# MORGAN OFFSHORE WIND PROJECT: GENERATION ASSETS

## Annex 3.5: Response to Natural England ExQ2 MM2.10 submission: Sub bottom profile surveys - clarification note

Document Number: MRCNS-J3303-RPS-10261

**Figure 1.1: Modelled disturbance ranges for Sub Bottom Profilers (SBP) based on a range of sound source levels (dB re 1 $\mu$ Pa<sup>2</sup>s re 1 m).**

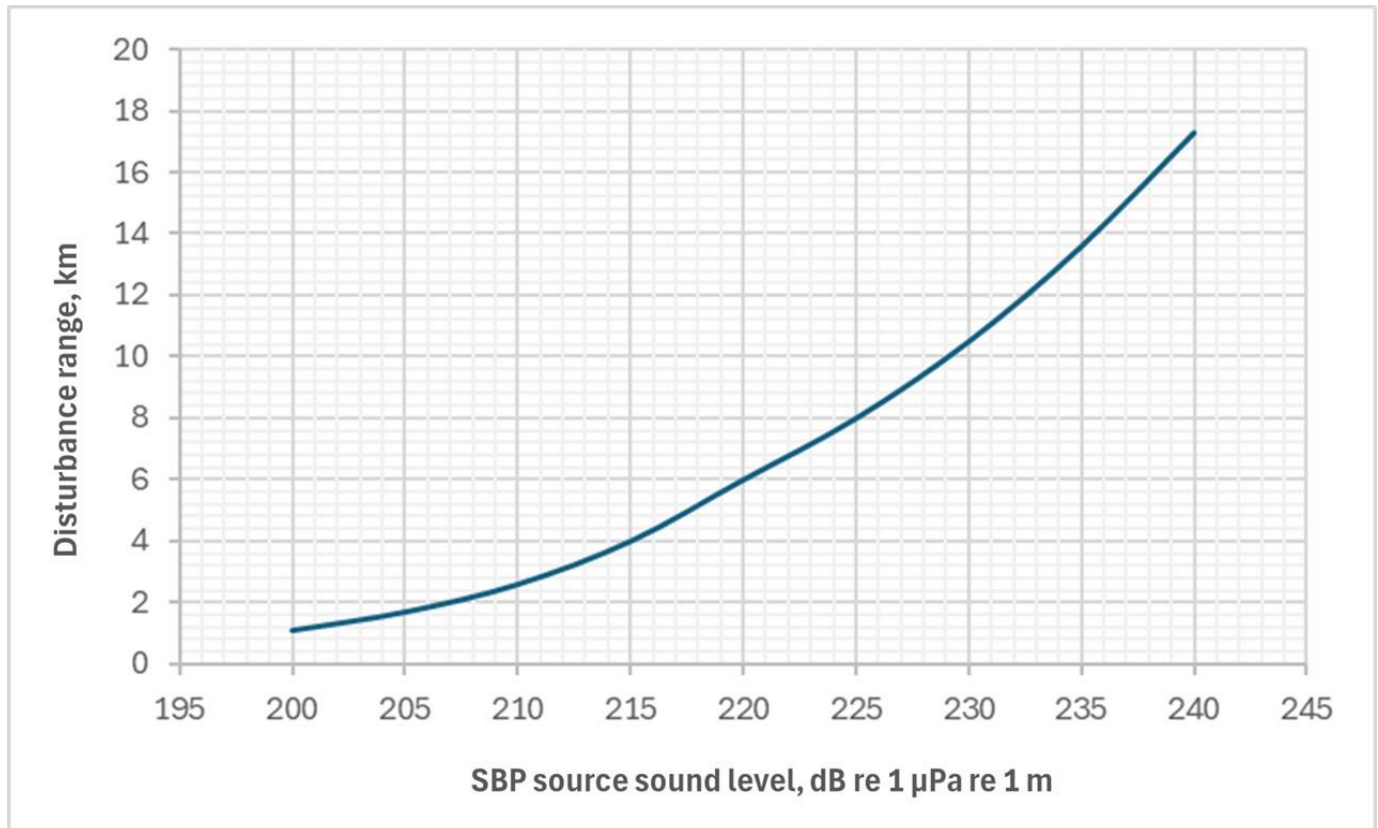
- 1.2.1.4 The Applicant has undertaken further SBP noise modelling for a range of source levels (otherwise applying the same parameters to the same model as used in the EIA, and presented in Volume 3, Annex 3.1: Underwater sound technical report (APP-028)) which encompasses the specifications for the parametric SBP with a source level of 215 dB re 1 $\mu$ Pa (SPL<sub>rms</sub>) (see Figure 1.1).

- 1.2.1.5 Figure 1.1 shows that for a SBP with a sound source of 240 dB re 1 $\mu$ Pa (SPL<sub>rms</sub>) estimated maximum range for onset of disturbance would extend out to more than 16 km but less than 18 km from the source (which aligns with those SBP disturbance ranges presented in Table 4.48 of Volume 2, Chapter 4: Marine mammals (S\_D6\_19 Volume 2, Chapter 4: Marine Mammals), representing the EIA SBP MDS. Figure 1.1 also shows that for a SBP with a sound source of 215 dB re 1 $\mu$ Pa (SPL<sub>rms</sub>) the estimated maximum range for onset of disturbance would extend out to ~4 km from the source, which is considerably smaller than the 17.3 km presented in Table 4.48 of Volume 2, Chapter 4: Marine mammals (S\_D6\_19 Volume 2, Chapter 4: Marine Mammals)). Furthermore, the parametric SBP identified as the most likely to be used at the Morgan Generation Assets allows for a highly focused sonar beam with minimal side lobes (preventing unwanted sound spreading through scattering), and as such it is expected that the equipment used in the surveys would have effect ranges in the order of ~4km, rather than the assessed 17.3 km (and therefore a much smaller area of effect). As such, any disturbance impacts to marine mammals would subsequently be considerably smaller than that presented in Volume 2, Chapter 4: Marine mammals (S\_D6\_19 Volume 2, Chapter 4: Marine Mammals)).

- Furthermore, given that revised modelling of SBP likely to be used at Morgan Generation Assets shows that ranges are more likely to be in the order of ~4 km rather than the assessed 17.3 km, the assessment presented in section 4.9.6 of Volume 2, Chapter 4: Marine mammals (S\_D6\_19 Volume 2, Chapter 4: Marine Mammals) is considered to be overly precautionary
